Release Notes

MLTG-CN

Version: 1.4.3-00335-9d5e29a
Enhanced from version 1.4.2-00287-d6b0c34

1. Operation Mode Modification

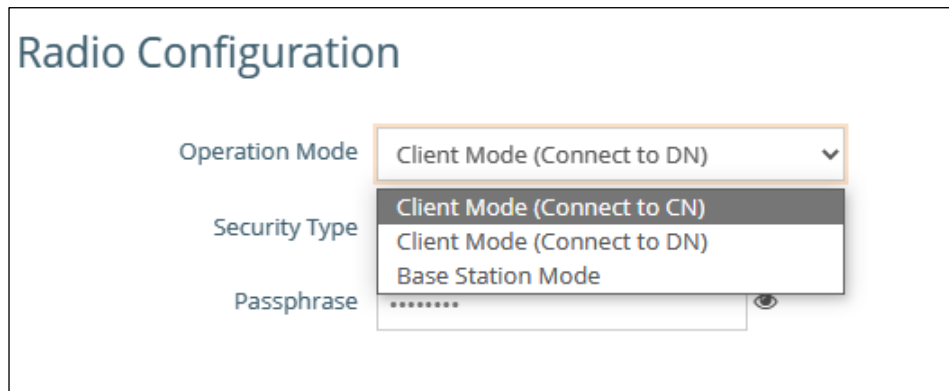
The two types of the client modes are renamed to prevent confusion. Also, it requires to configure the client mode now. When connecting with a DN, please configure it to “Client Mode (Connect to DN)”; when connecting with a base station mode CN, please select “Client Mode (Connect to CN)”.
